Architectural Review Board Agenda
4:00 PM Thursday, January 9, 2025
Sussex Civic Center – Committee Room Second Floor

MEMORANDUM

TO: Architectural Review Board
FROM: Gabriel Gilbertson, Community Development Director
RE: January 9, 2025 Architectural Review Board
DATE: Monday, January 6, 2025

BUBBLES SUSSEX

EAST ELEVATION

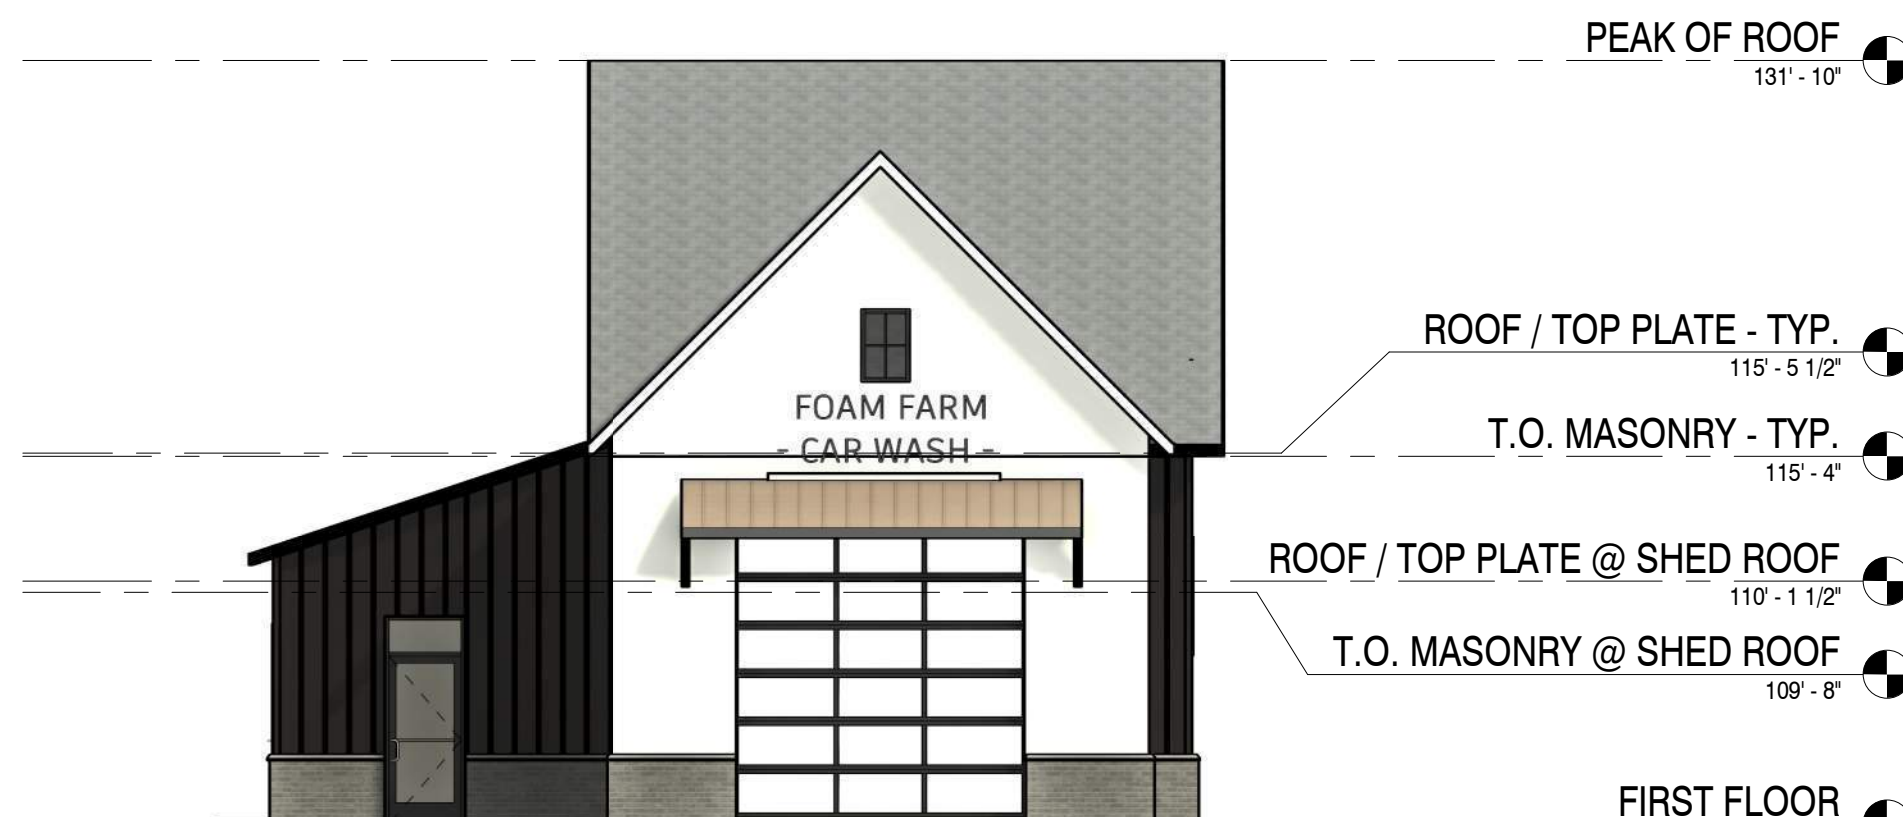
- The building is done in a more traditional architecture than the previously reviewed building with gabled ends and a gabled center accent. A stone base and board and baton accents highlight portions of the building.
- The building meets the minimum height and setback requirements for the Code.

- The submitted plans do not show any roof-mounted HVAC units. If those are to be installed, a plan will need to be submitted to Staff with their locations and methods of screening.

1. Are there any concerns with the various plans?
2. The ARB reviewed the plans at their previous meeting and requested the applicant submit revised elevations showing how the window percentage was calculated and potential other options of reducing the window percentage on the street elevation and submitted a revised landscape plan increasing the number of shrubs to what was previously approved.
